Attachment Ia
Marked-up Technical Specification Pages
Catawba

Attachment Ib
Marked-up Technical Specification Pages
McGuire

Attachment II
Justification and Safety Analysis

FIGURE 2.1-1
REACTOR CORE SAFETY LIMITS - FOUR LOOPS IN OPERATION

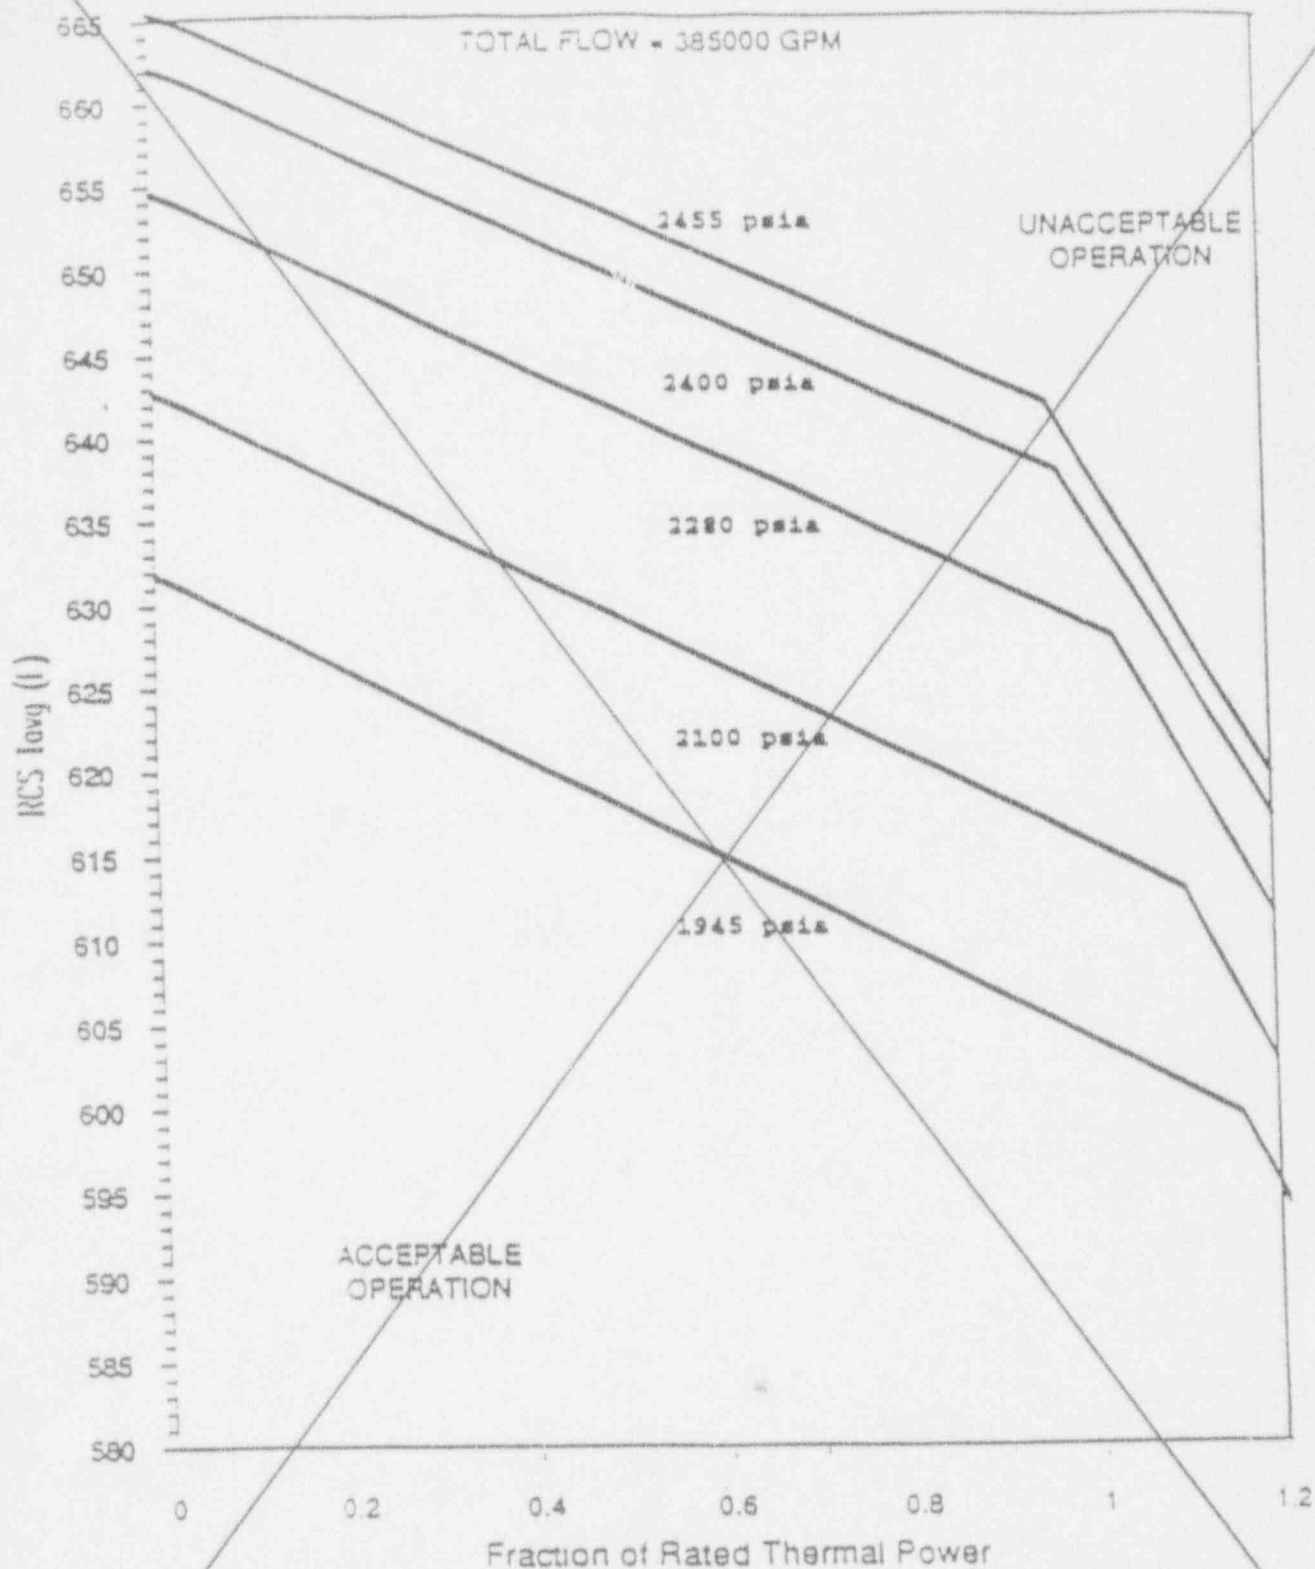
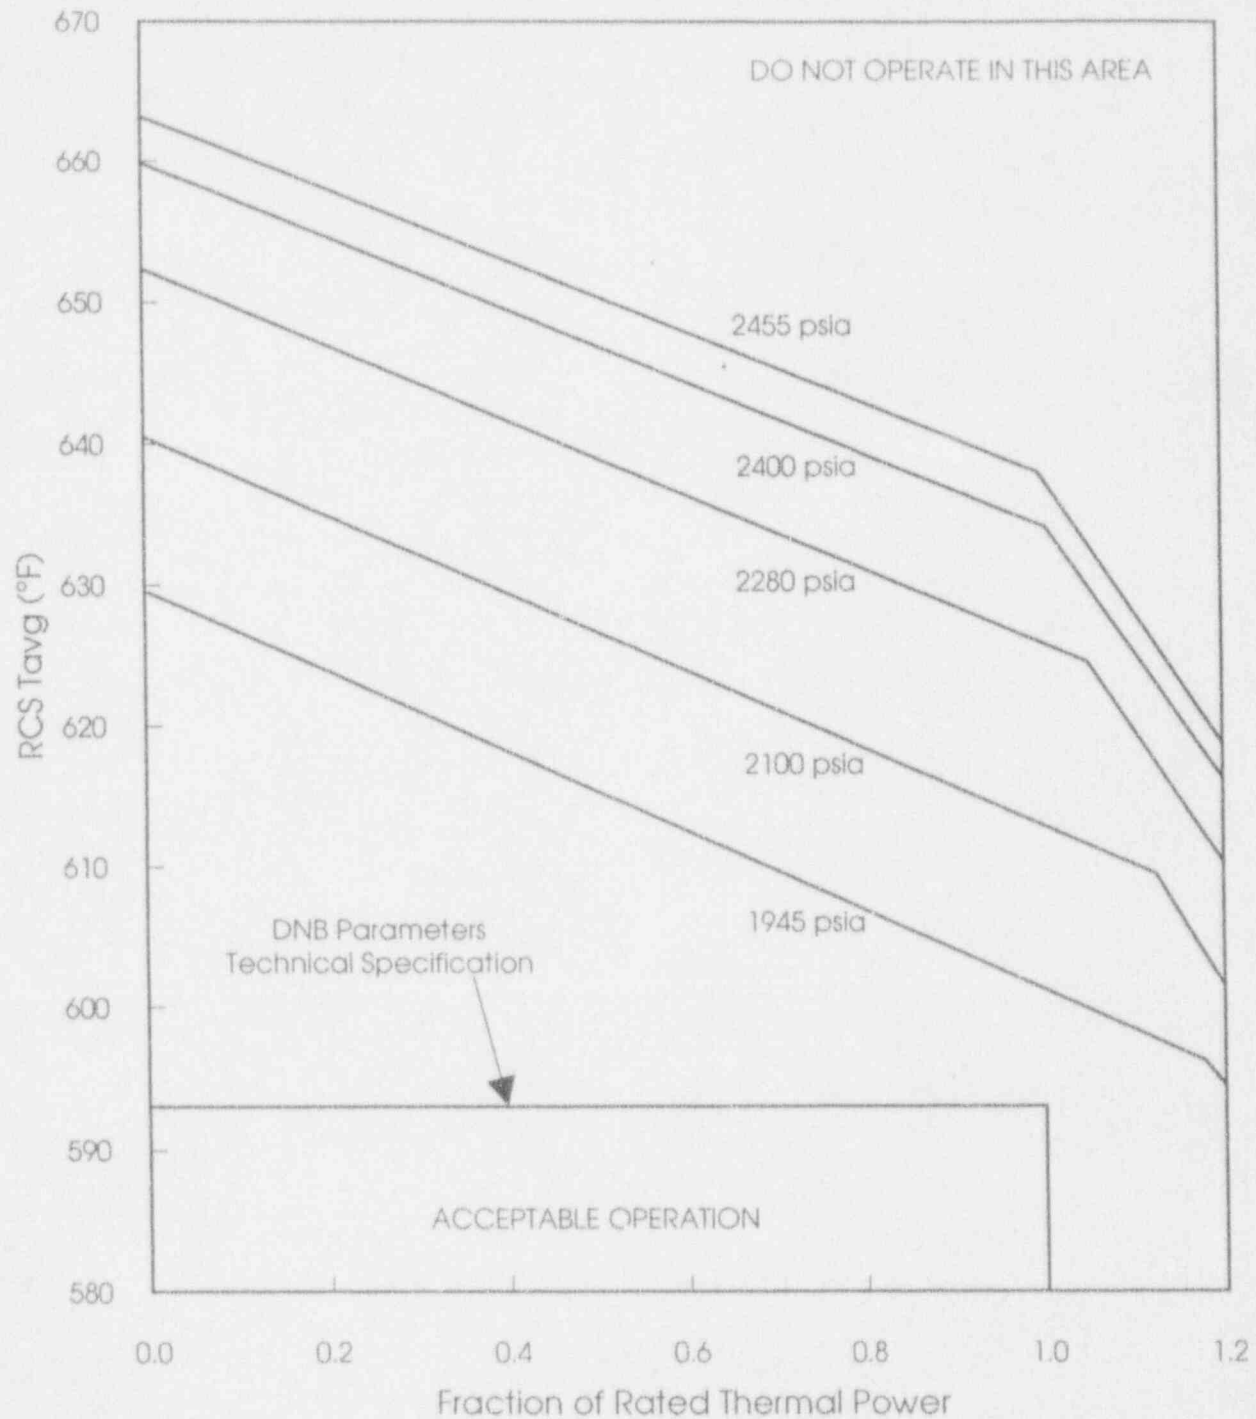
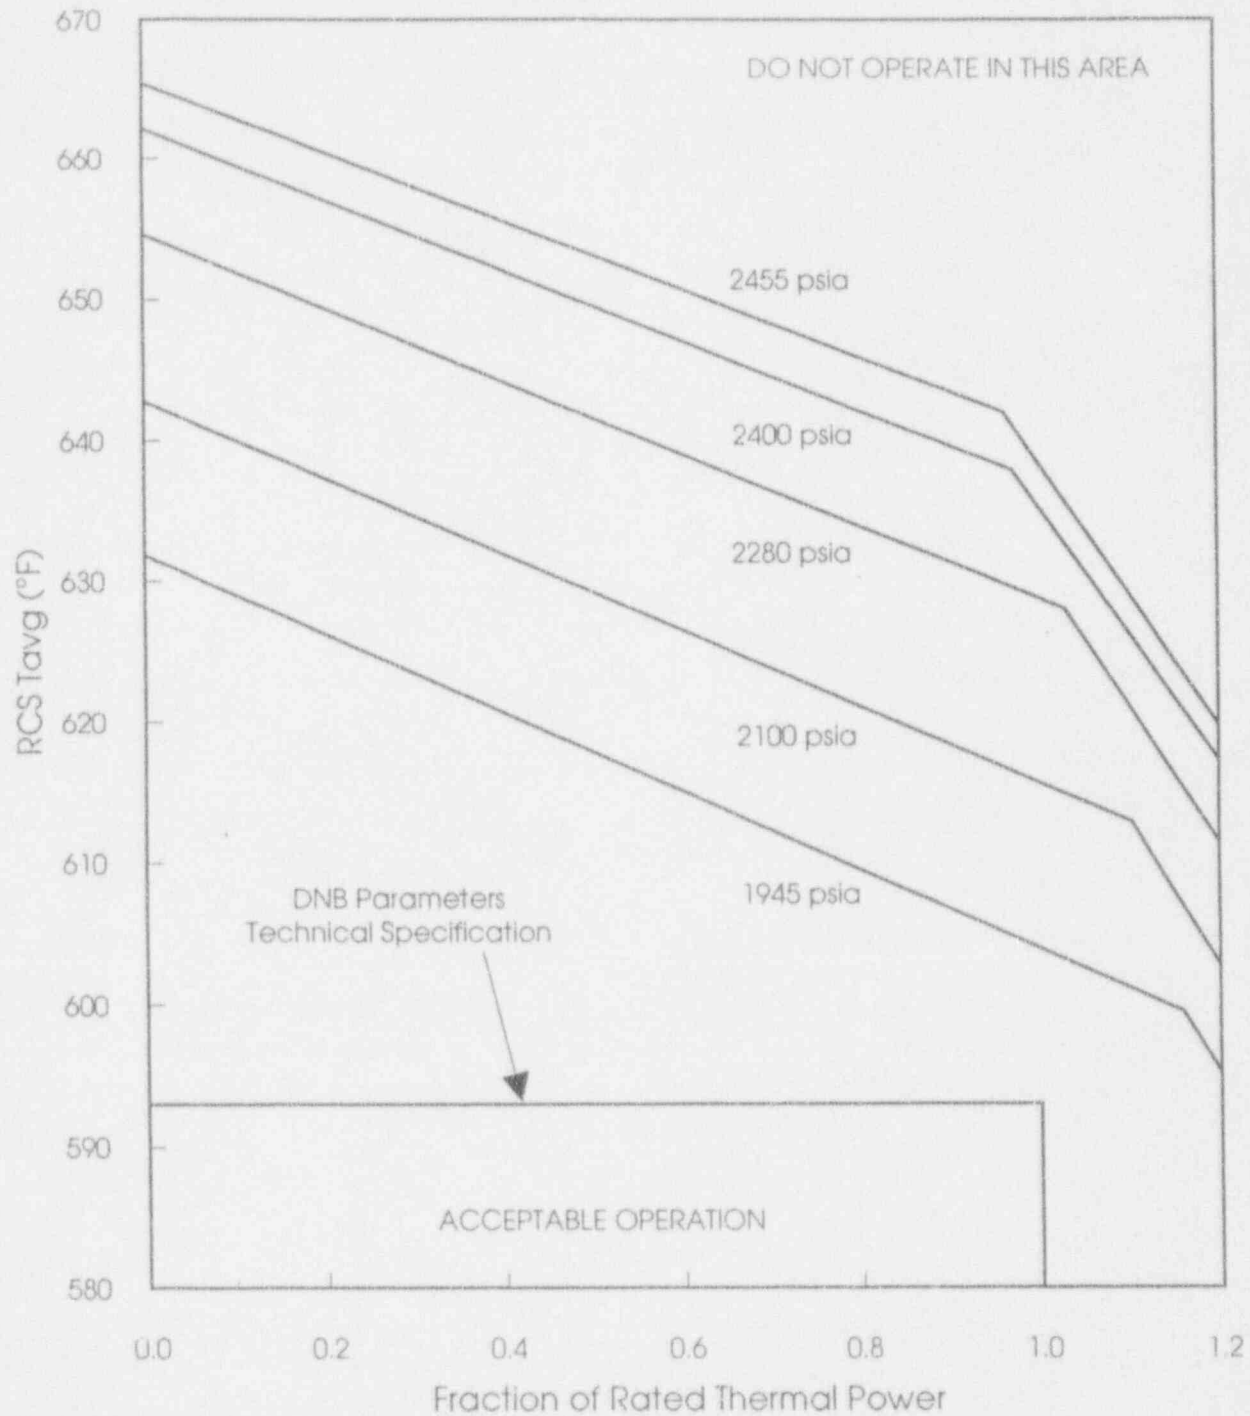
REPLACE

The curves of Figure ~~2.1-1~~ ^{2.1-1a for Unit 1 and 2.1-1b for Unit 2,} show the loci of points of THERMAL POWER, Reactor Coolant System pressure and average temperature below which the calculated DNBR is no less than the design DNBR value, or the average enthalpy at the vessel exit is less than the enthalpy of saturated liquid. are more restrictive than the actual safety limit curves.

Figure 2.1-1a
REACTOR CORE PROTECTION LIMITS - FOUR LOOPS IN OPERATION

Figure 2.1-1b
REACTOR CORE PROTECTION LIMITS - FOUR LOOPS IN OPERATION

Figure 3.2-1 Reactor Coolant System Total Flow Rate Versus Rated Thermal Power - Four Loops in Operation

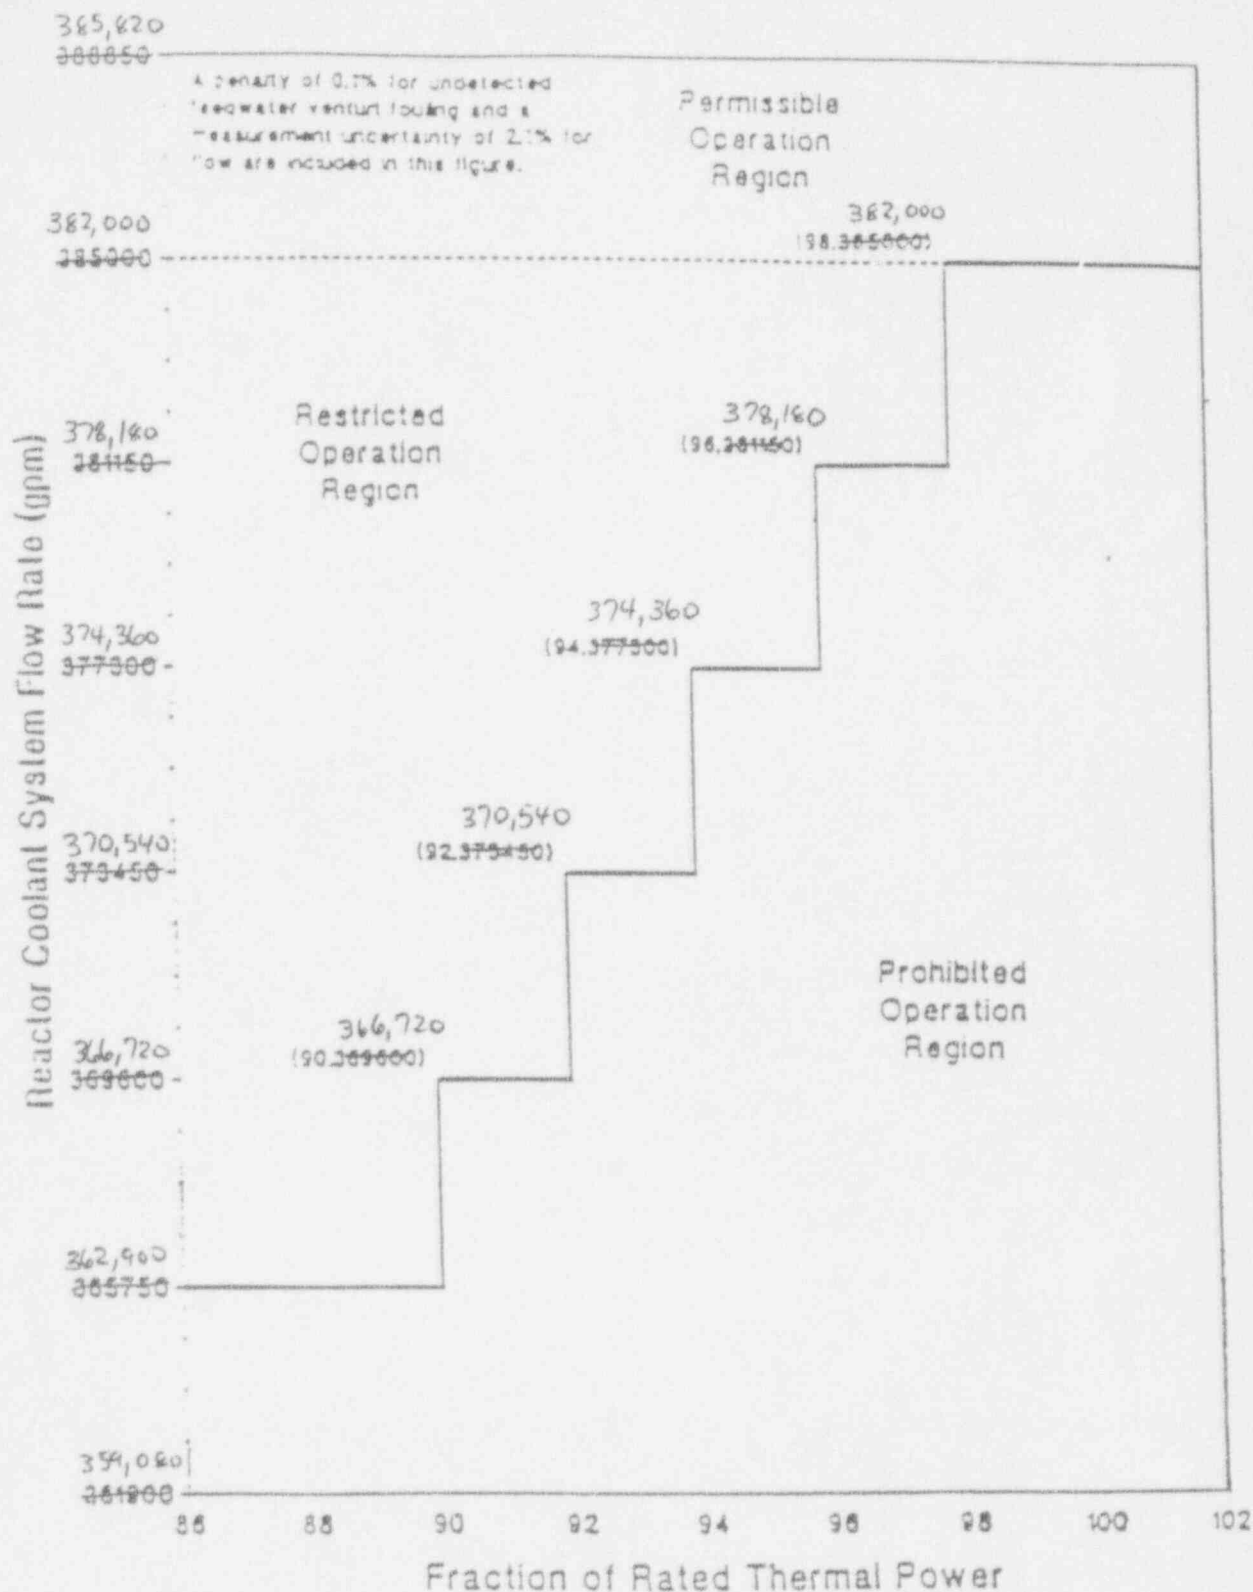
To alleviate this concern, analyses have been performed to justify reduction in the minimum RCS flow to 382,000 gpm. These analyses show that the reduced flow rate will not have a significant impact on any accident analyses presented in Chapters 3, 4, 6, or 15 of the Final Safety Analysis Report (FSAR).

The thermal hydraulic design for the McGuire and Catawba units was analyzed with the reduction in RCS minimum measured flow (MMF) to 382,000 gpm. The reduced flow rate resulted in a slight reduction of the margin in the core DNB limits. Technical Specification Figure 3.2-1, Reactor Coolant System Total Flow Rate Versus Rated Thermal Power - Four Loops In Operation, was revised to reflect the lower allowable flow rate. The Axial Flux Difference limits, Technical Specification Section 3.2.1, are unchanged and all of the current thermal hydraulic design criteria are satisfied at the reduced flow conditions.
